WEST SUSSEX COUNTY COUNCIL CONSULTATION

TO:	Horsham District Council - FAO: Nicola Pettifer
FROM:	WSCC – Highways Authority
DATE:	8 September 2025
LOCATION:	Land East of Tilletts Lane Warnham
SUBJECT:	DC/25/1155 Erection of 59 dwellings with associated open space, landscaping, parking, access, and drainage infrastructure.
RECOMMENDATION:	More Information

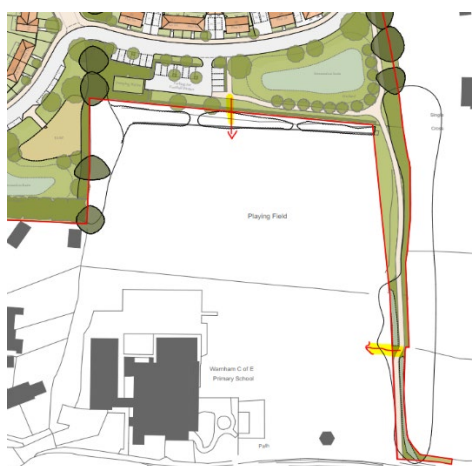
Permeability will be retained for walking and cycling to encourage and promote sustainable and active transport modes over the vehicle. The landscaping plans show proposed tree and bench and bollard treatments north of plots 49/50 and south of plot 4 which should allow sufficient width for a cycle or pedestrian through route. Currently the approx. 1.2m width between bollard and verge/dwellings is too narrow. LTN 1/20 at para 6.4.3 states, “Cycle Lanes less than 1.5m wide should not normally be used as they will exclude the use of the facility by larger cycles and are therefore not inclusive”. There should be a minimum 1.5m width and any landscaping feature (e.g. tree/bench) should be kept to edge of carriageway and a single bollard used – this will prevent vehicle access whilst maximising space for pedestrians and cyclists. The current treatment does not do this. See fig. 7.1 of LTN1/20 for examples of acceptable modal filters.

It is worth noting that the site proposes an internal connection to PROW footpath 1430 which runs east of the Primary School. Considering the proposed football pitch car parking, a link should be shown for pedestrians to the Playing Field. It would also be beneficial for a link from PROW 1430 to the Primary School grounds be provided, if possible, as indicated below:

- Pedestrian link from pitch car parking to playing field and from PROW 1430 to the Primary School grounds.
- Some visitor bays to be marked with additional lining/hatching as accessible bays.
